APPLICATION NO.	FILING DATE	FIRST NAMED INVENTOR	ATTORNEY DOCKET NO.	CONFIRMATION NO.
09/841,992	04/25/2001	Sadeg M. Faris	1101.004C	6677

Office Action Summary

Detailed Action

FIG. 7

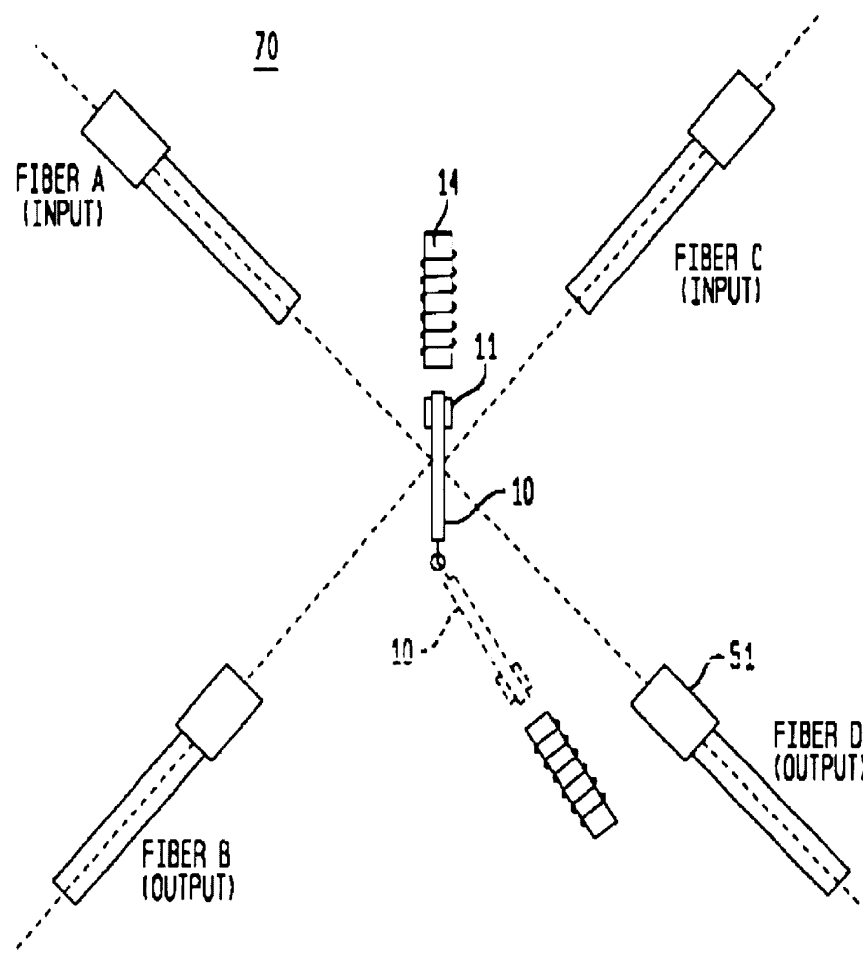
Claims 40 – 41, 57, 76-77 are rejected under 35 U.S.C. 102(b) as being clearly anticipated by Jin et al. (USPATNO. 6,256,430) or Young et al (USPATNO. 6,091,867).

Figure 7 of Jin et al disclose the instant invention as shown below.

FIG. 10

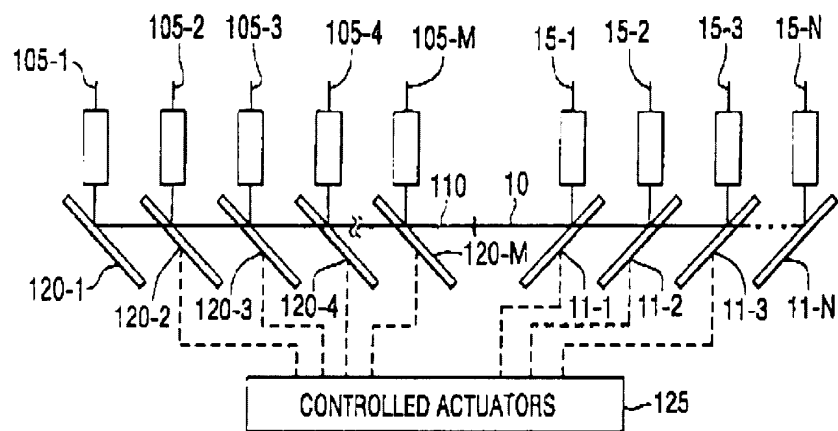
Figure 10 of Young et al also shows the instant invention as shown below

Thus, the above-mentioned claims are clearly anticipated by the above-mentioned references.
